BLYMYER
ENGINEERS, INC.

February 14, 1992
BEI Job No. 91175

Subject: Work Plan for an Initial Subsurface Investigation
Lanaidor, Inc.
925 89th Avenue
Oakland, California

Re: Comment on Work Plan for an Initial Subsurface Investigation
at Lanaidor, Inc., 925- 89th Ave., Oakland 94621

BLYMYER ENGINEERS, INC.		LEGEND MONITORING WELL PROPOSED MONITORING WELL GROUNDWATER CONTOUR 1-28-92	PROJECT LANAIDOR, INC. OAKLAND, CA GROUNDWATER GRADIENT 1/28/92	FIGURE 1
BEI JOB NO. 91175	DATE 2/92

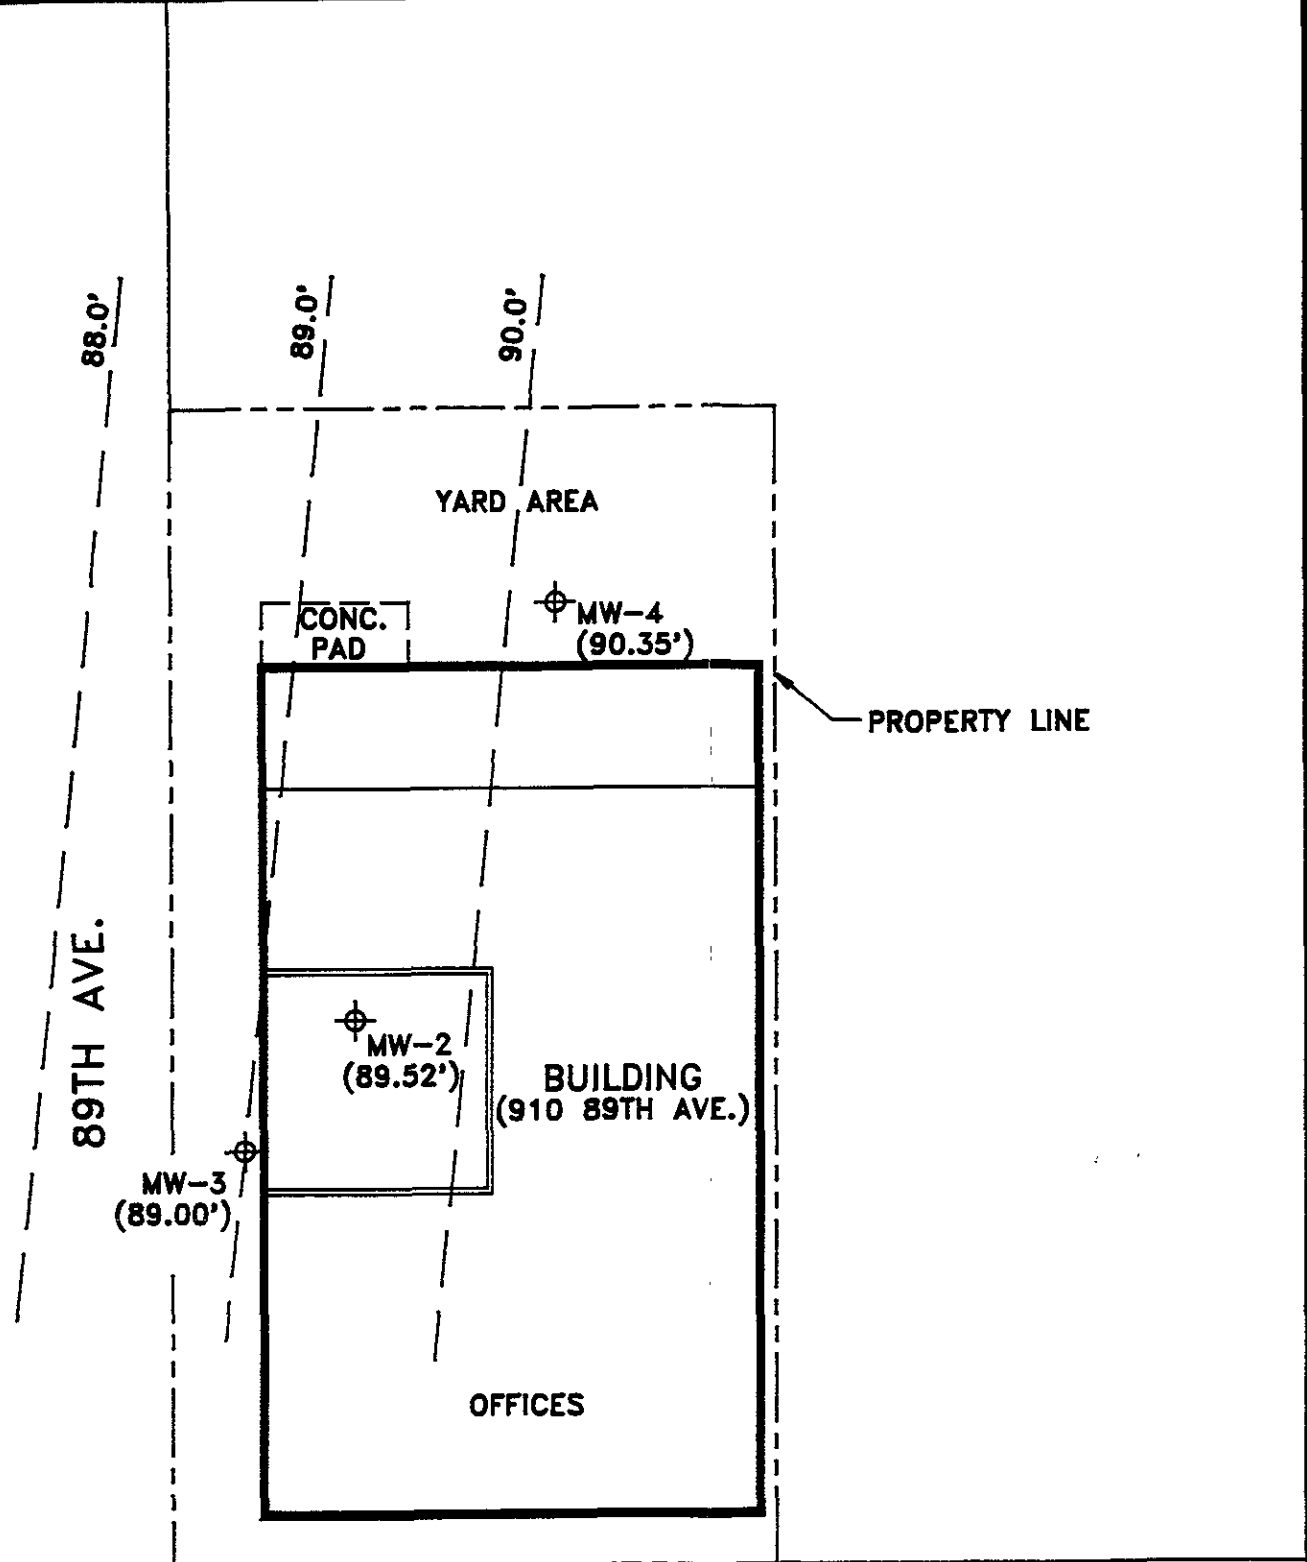
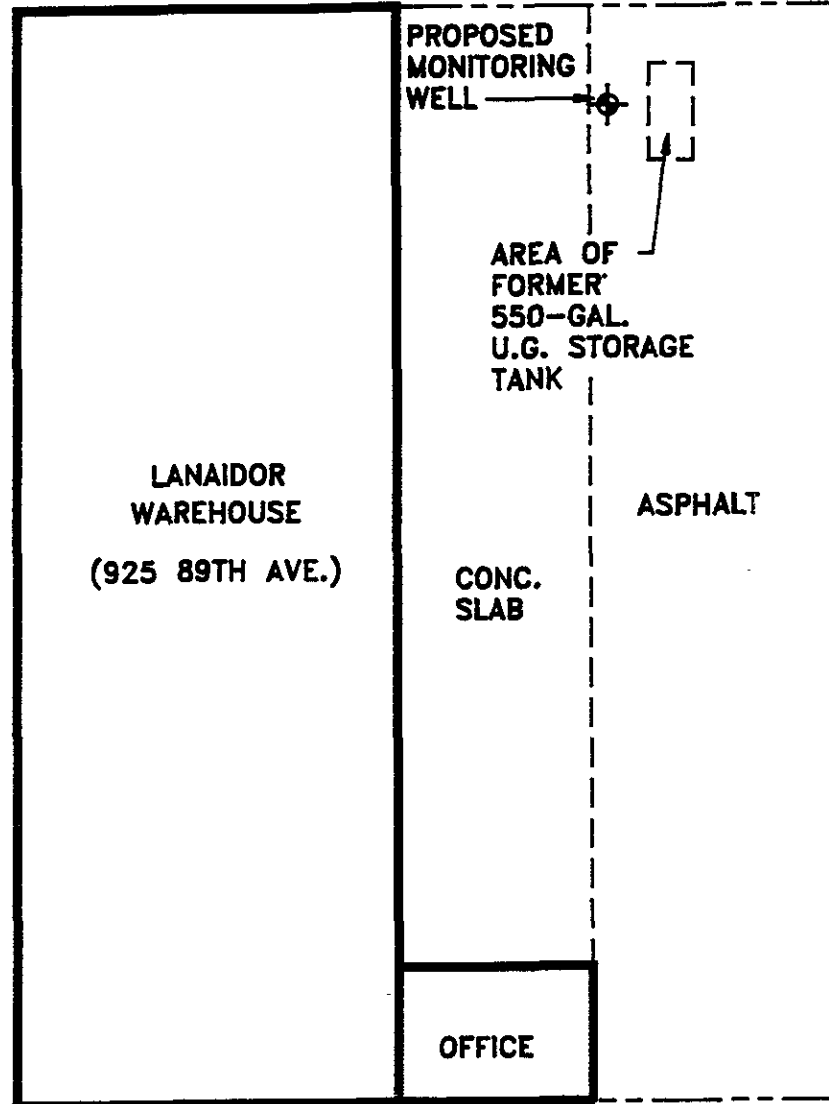
As I informed you in our telephone conversation today, the groundwater gradient shown on the Figure in Blymyer Engineers letter of February 6, 1992 for the subject site is incorrect. The correct groundwater gradient is shown on the attached Figure 1.

The groundwater gradient was determined by measuring the depth to groundwater in the three monitoring wells located at 910 89th Avenue, which is across the street from the subject site. The current groundwater gradient is 0.03 in a N 23° W direction. Those measurements, along with the top-of-casing (TOC) elevations surveyed by Terratech, and the computed groundwater elevations are presented in Table I. This gradient is almost 180° different than the gradient measured by Terratech at this site in August 1989.

Please note that Terratech's measurements were made in August and the current gradient was computed with measurements taken in January. The topographic map of the vicinity shows a buried stream channel just west of the site. Both of these factors may affect the local groundwater gradient.

Blymyer Engineers has arranged to measure the depths to groundwater in the three wells at 910 89th Avenue again to confirm the current gradient. Another measurement will be taken in March, prior to the initiation of field work at the site. During well installation Blymyer Engineers will survey the top-of-casing elevations of the wells at 910 89th Avenue to further clarify the local groundwater gradient calculations.

BLMYER ENGINEERS, INC. 		LEGEND  MONITORING WELL  PROPOSED MONITORING WELL  GROUNDWATER CONTOUR 1-28-92	PROJECT LANAIDOR, INC. OAKLAND, CA GROUNDWATER GRADIENT	FIGURE
BEI JOB NO. 91175	DATE 2/92

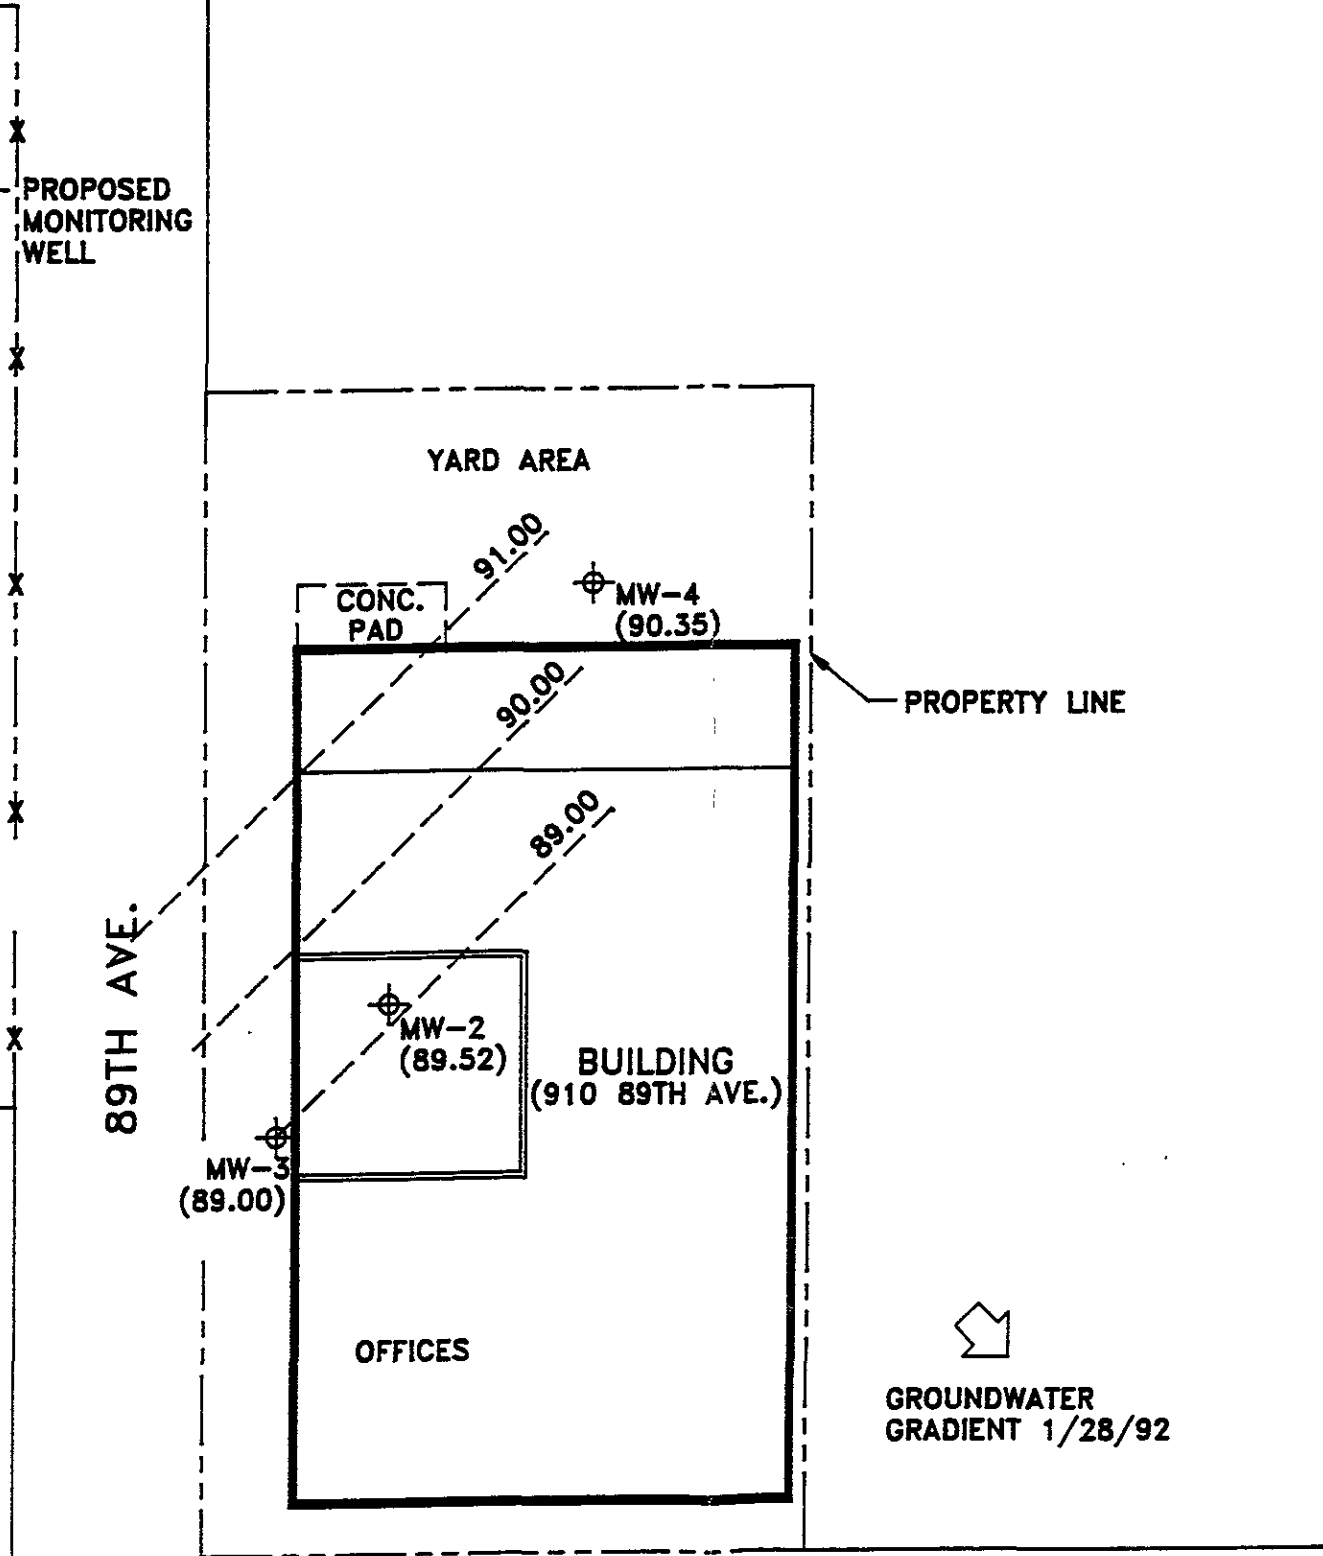
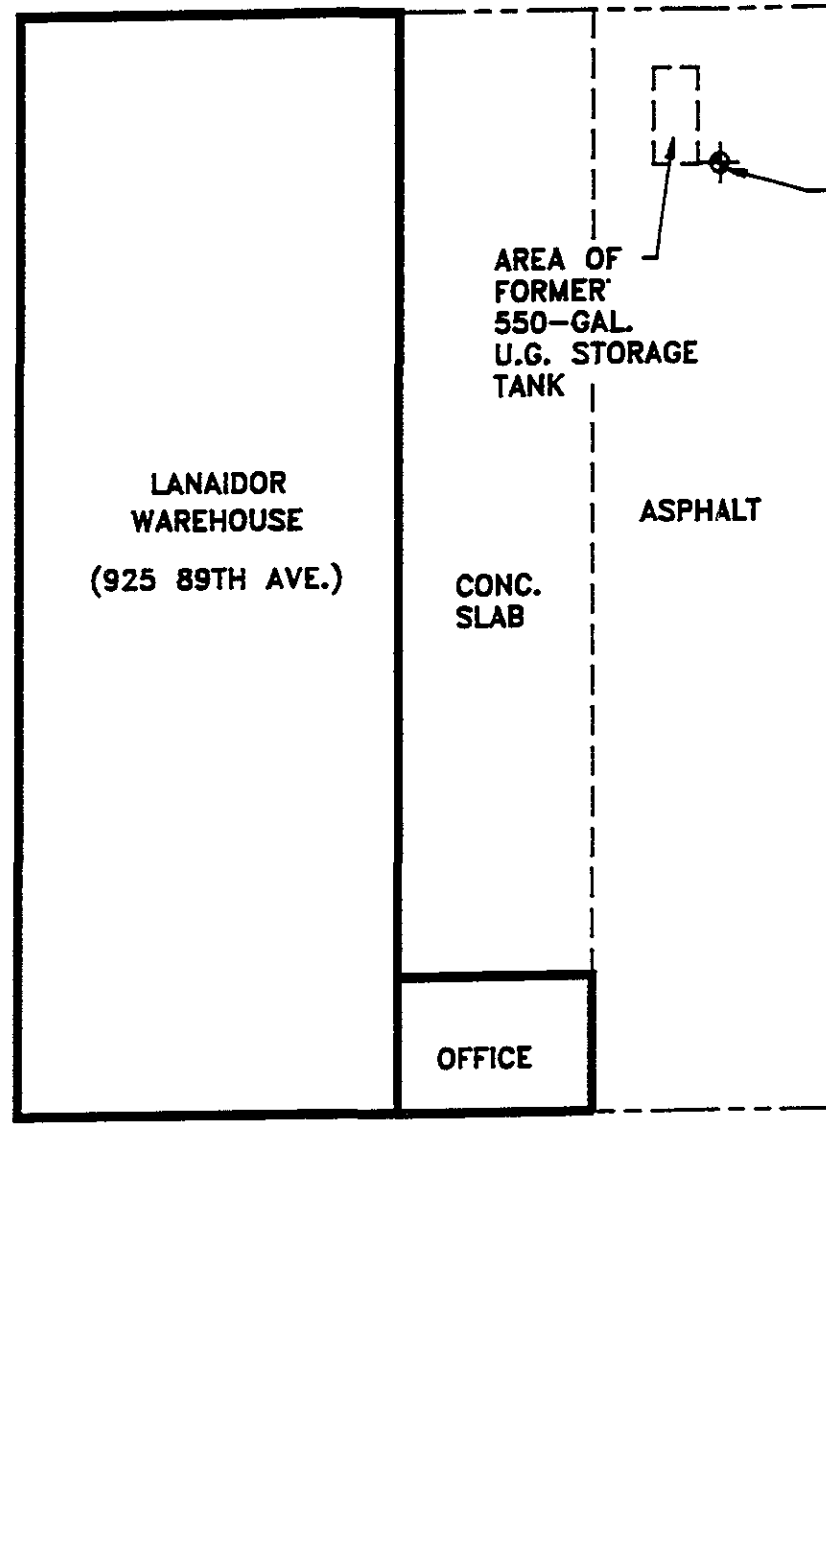
Using this data, groundwater contours for the area have been plotted on the attached Figure. If you compare this Figure with Figure 2 of the previously submitted Work Plan you will see that the groundwater flow direction is almost identical to that measured by Terratech in August 1989. The groundwater gradient computed from this data is 0.05 feet/foot in the direction shown on the attached Figure (approximately due south).
